**LEGAL ADVERTISEMENT
HISTORIC PRESERVATION BOARD
CITY OF PORTLAND
Public comments will be taken at all meetings**

**HISTORIC PRESERVATION BOARD
CITY OF PORTLAND, MAINE**

**PUBLIC HEARING
251 and 261 COMMERCIAL STREET**

Application For: Certificate of Appropriateness for Elevated Building Connector

Window Washing:

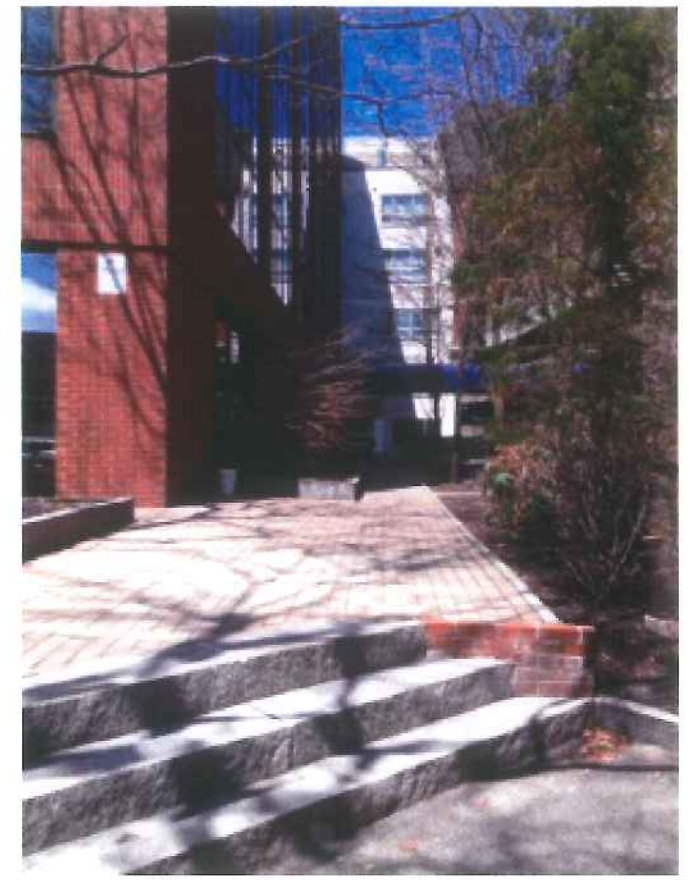
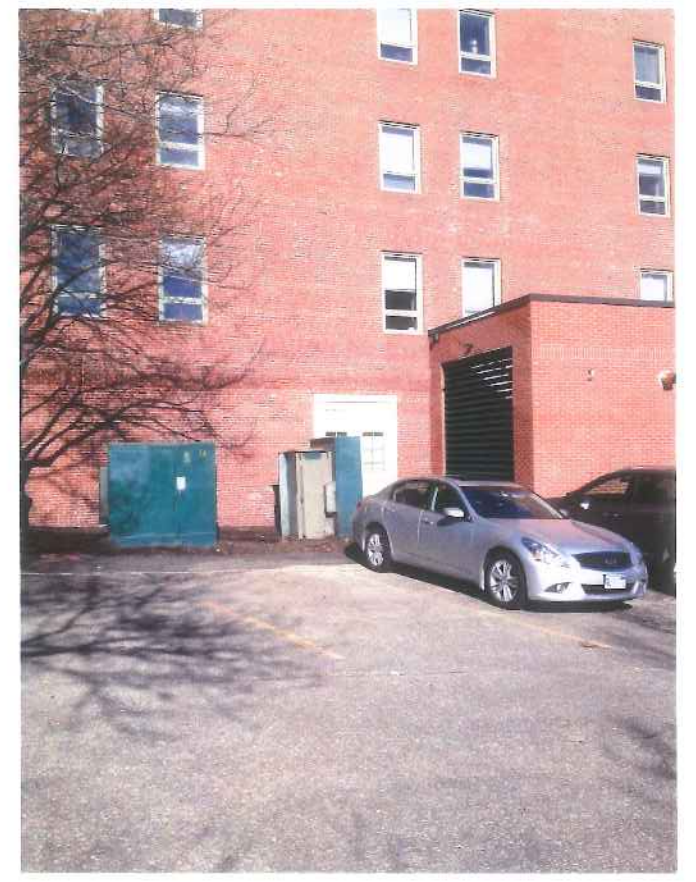
- Board members asked a number of questions about the proposed perforated metal screens, especially with respect to their placement in relation to the curtainwall system. Practical considerations, such as how the glass might be cleaned, should be addressed in the design.

Where there are windows behind the perforated metal panels, these windows will tilt in for cleaning (this will only be necessary at the small section on the south end of the bridge that connects to the brick building).

Lighting:

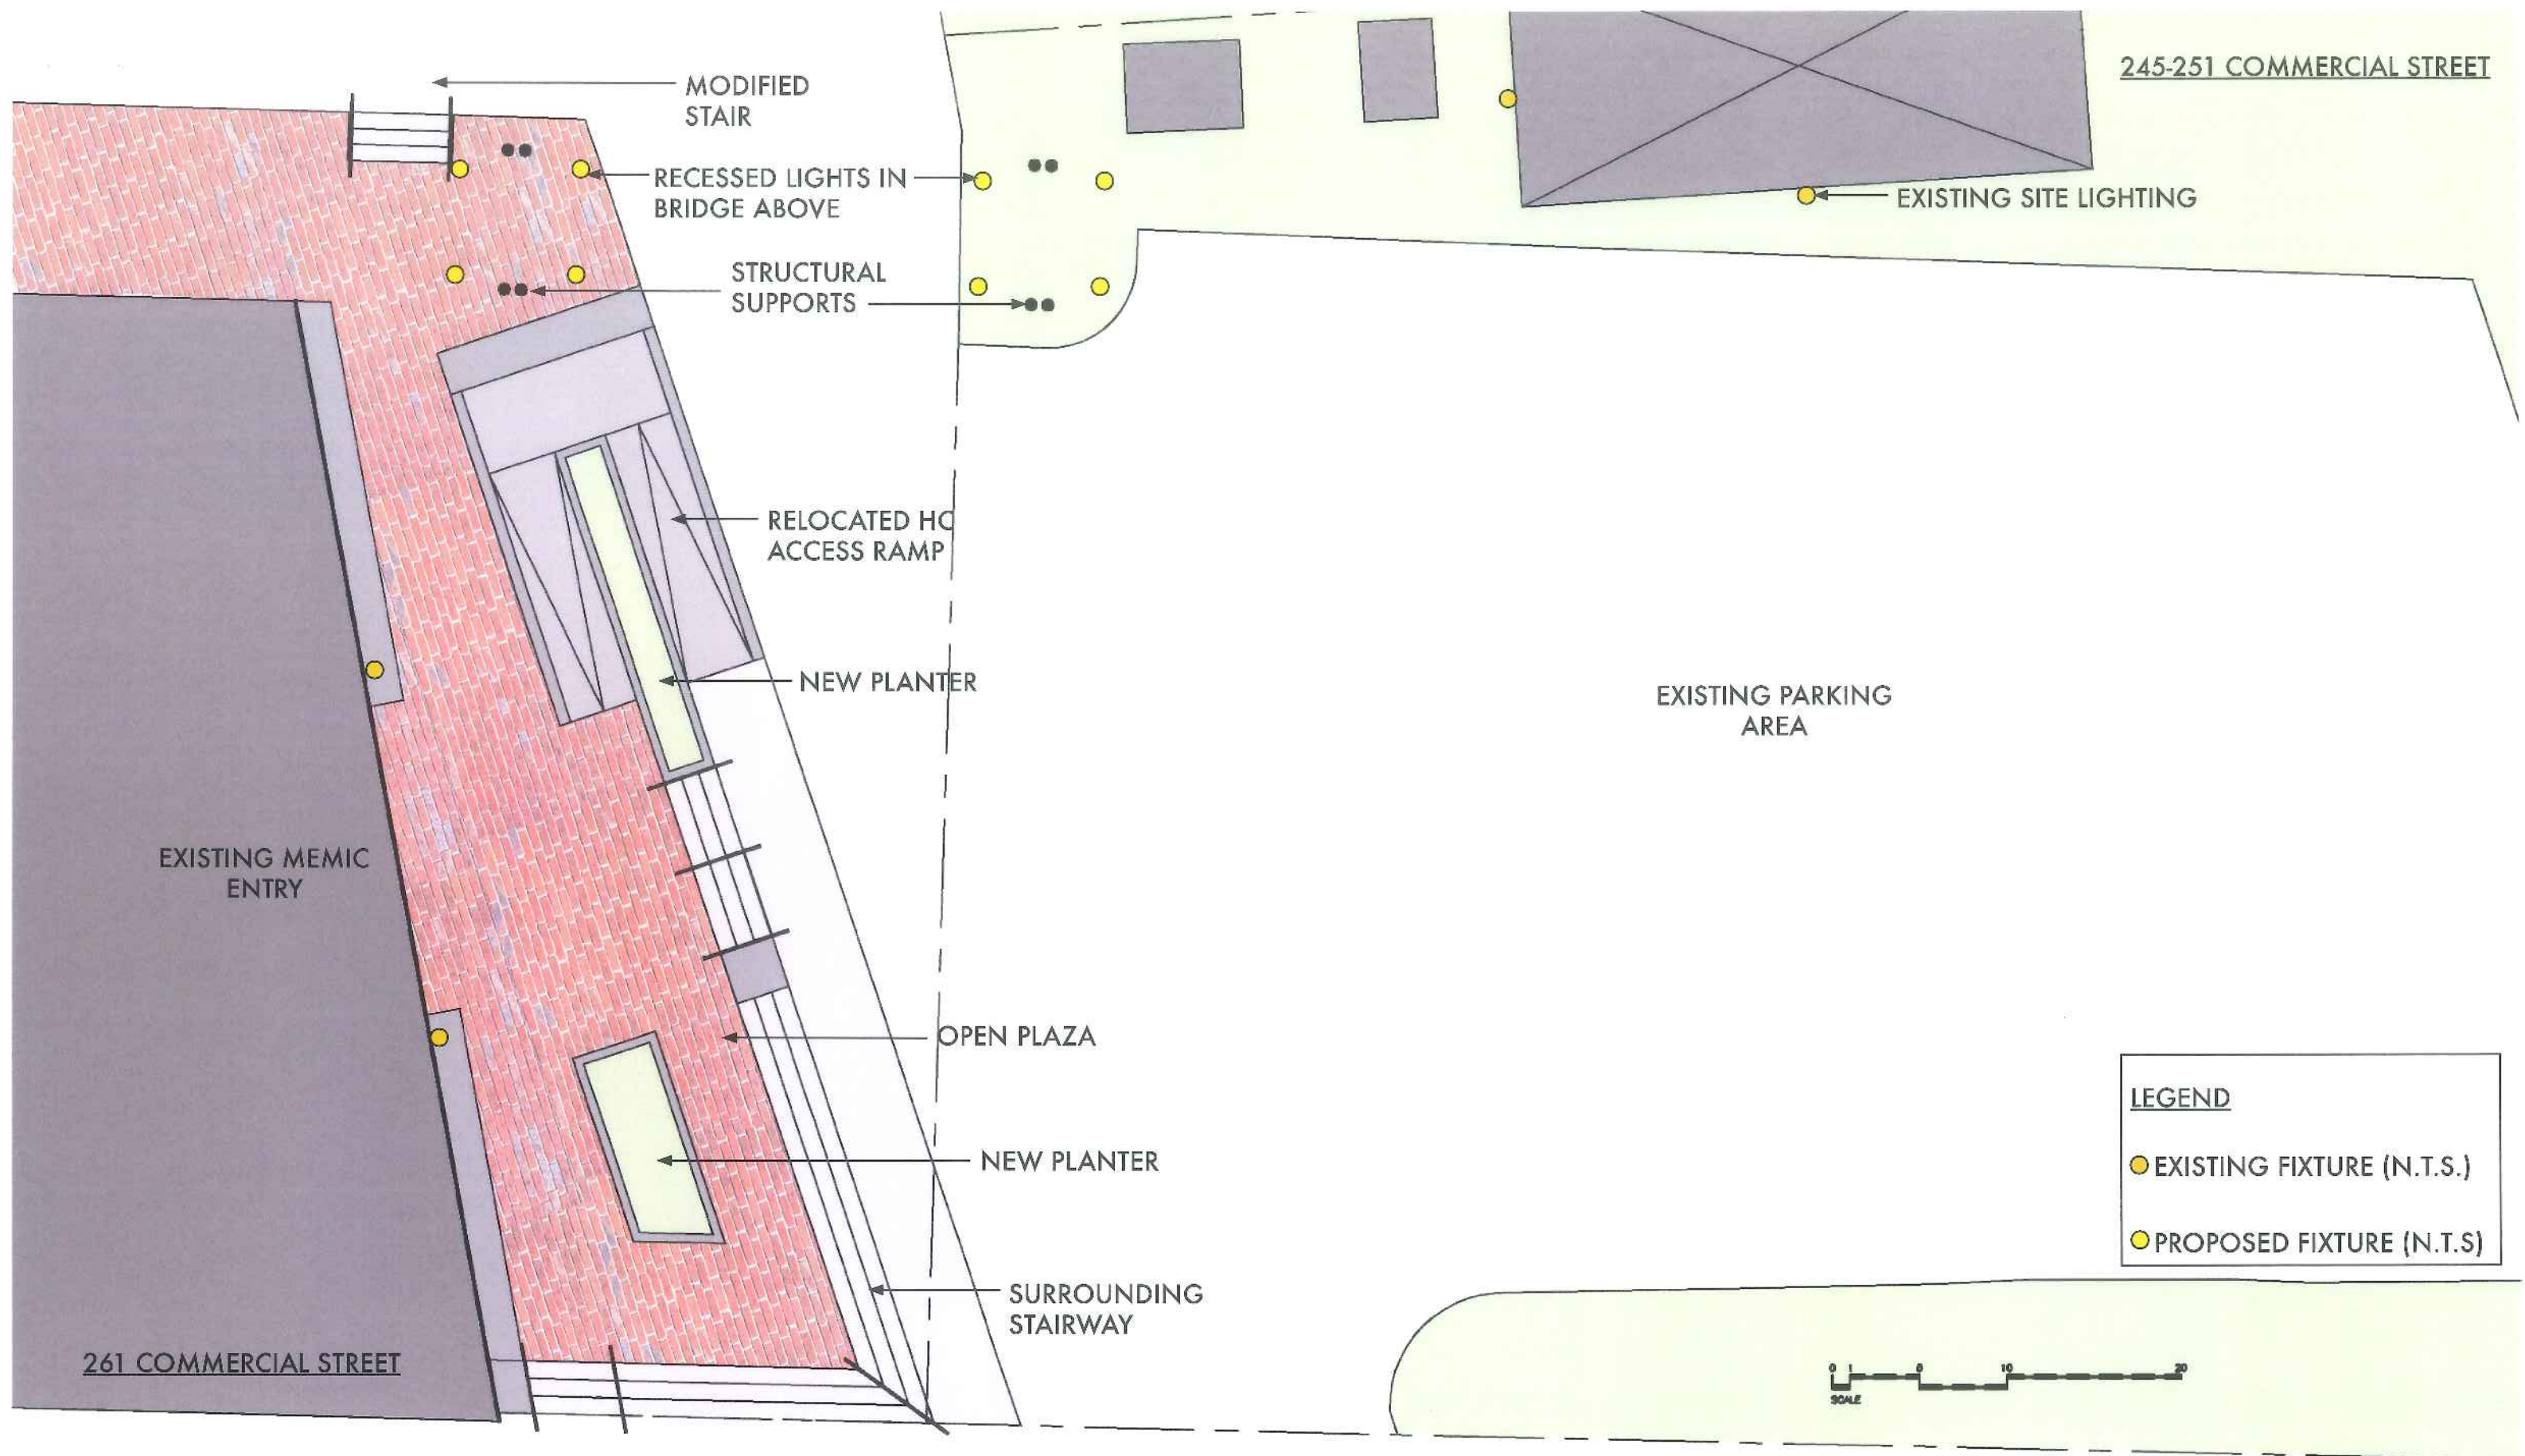
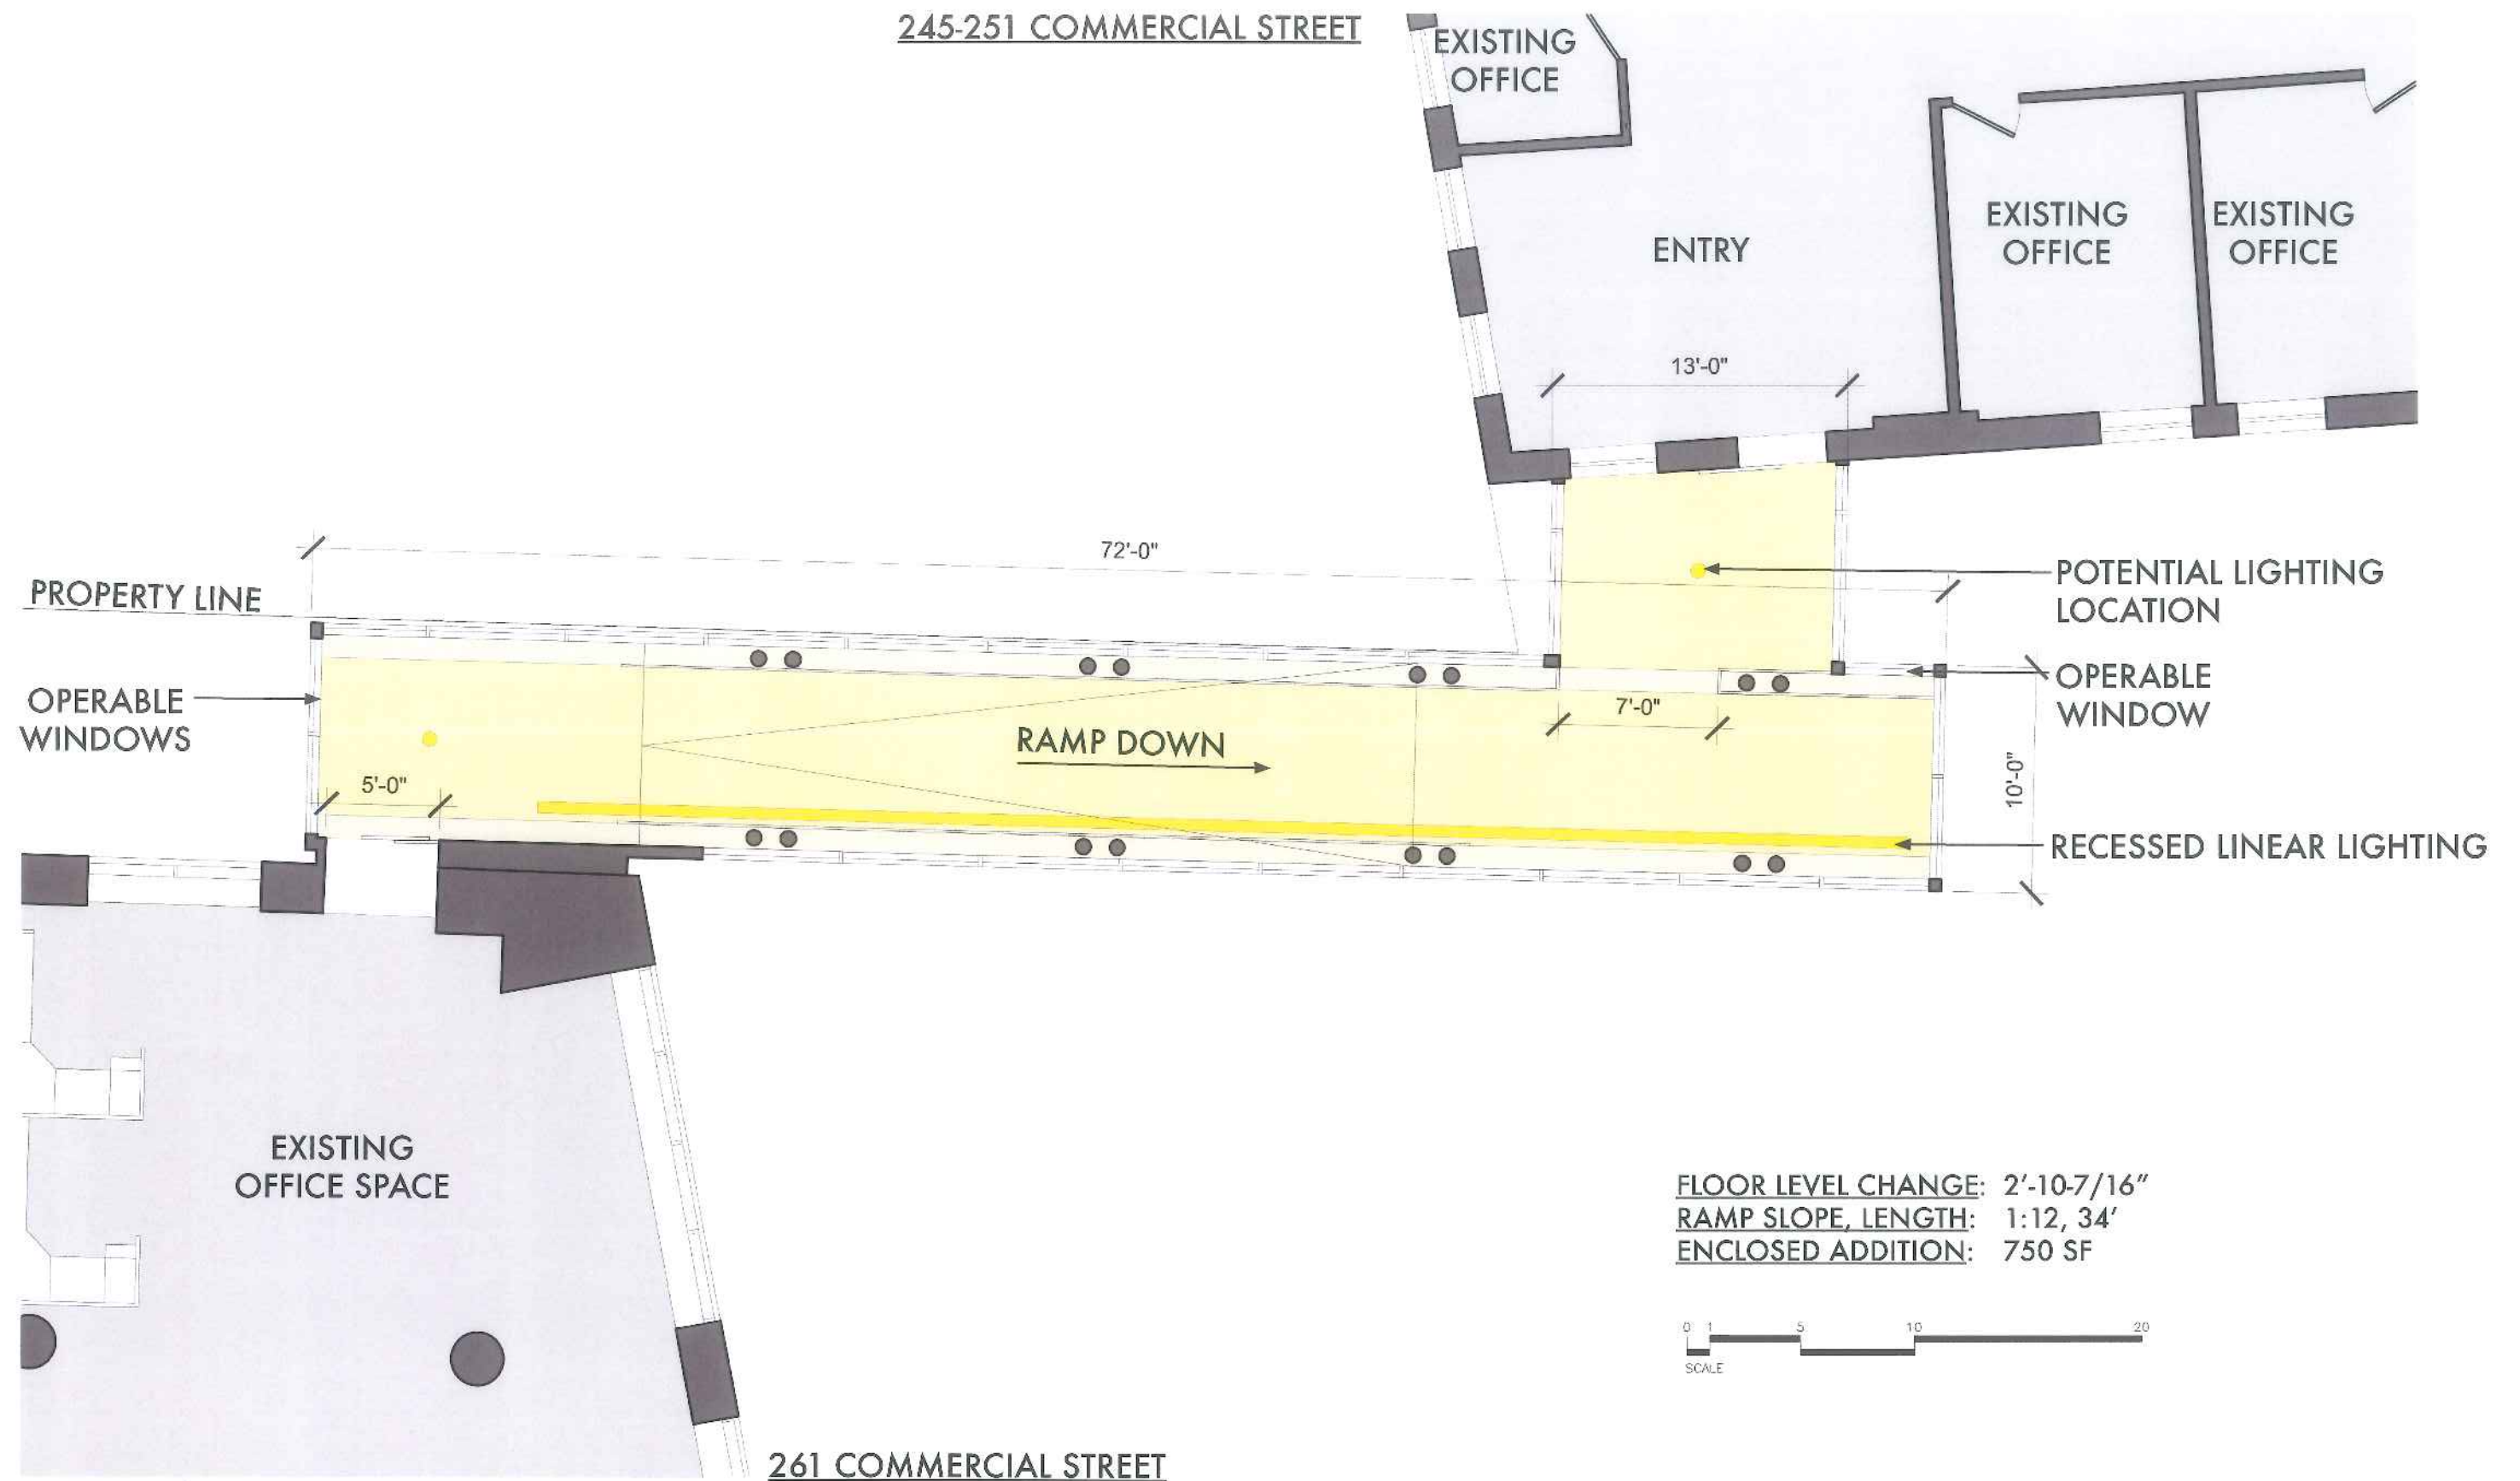
- Given the highly glazed treatment of the proposed connector and the need to provide lighting within it, Board members noted that the bridge will be visually prominent during evening hours. The architect was asked to develop a lighting plan for the Board's review.

Inside the bridge we are recommending recessed linear fluorescent lights along the west edge of the ceiling, on both floors, and recessed downlights in front of the doors at either end of the bridge. The linear fluorescent fixtures will have a parabolic reflector to direct the light to the solid walls and floors of the bridge (see building section). We will also have exit signs, with green letters, and emergency lighting at either end of the bridge.

Outside the bridge we are recommending small cut-off downlights that will have narrow beams of light that will shine down at the bases of the bridge structure. These will provide security lighting for this area of the property and some minor lighting of the structure. Catalogue cuts are included in our package for your review.
